# United States Patent and Trademark Office

APPLICATION NO.	FILING DATE	FIRST NAMED INVENTOR	ATTORNEY DOCKET NO.	CONFIRMATION NO.	
09/806,800	06/25/2001	Adriaan Retief Swanepoel	0182.00001	6013	
7590 05/31/2005			EXAM	EXAMINER	
Gerald E McG Bliss McGlynn			BALSIS,	SHAY L	
2075 West Big Beaver Rd Suite 600			ART UNIT	PAPER NUMBER	
Troy, MI 48084			1744		
			DATE MAILED: 05/21/2004	•

#### **DETAILED ACTION**

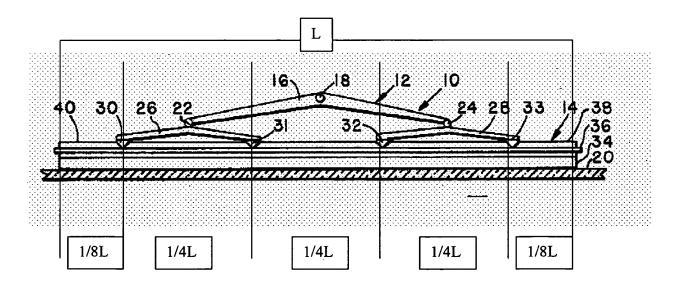
Wittwer teaches a wiper comprising a force-applying member (12) connected to the center backbone at two spaced apart points (31, 32). Wittwer teaches a superstructure with four pairs of equally spaced apart claws (30, 31, 32 and 33) that slidably engage with the backing strip (26) by means of claws with pin type structure that engage around the outer exposed longitudinal slot edge portions of the flexible backing strip. The remote claws (30, 33) are at a location 1/8 the length of the wiper blade element in from the ends. The four points of pressure being applied to the backing strip at equally spaced apart locations between the remote pressure points beneath the claws (30, 33). It can be determined that the spacing between the two points

(31, 32) is ¼ the length of the wiper blade and the ratio of spacing to the total length is ¼ (see figure below), therefore, S=0.25\*L and R=0.25 which falls in the ranges claimed by the applicant. The preferred spacing distance  $S_p$  between the spaced apart points is *about*  $S_p=0.363*L-0.000146*L^2$ . The preferred ratio  $R_p$  is *about*  $R_p=0.363-0.000146*L$ .
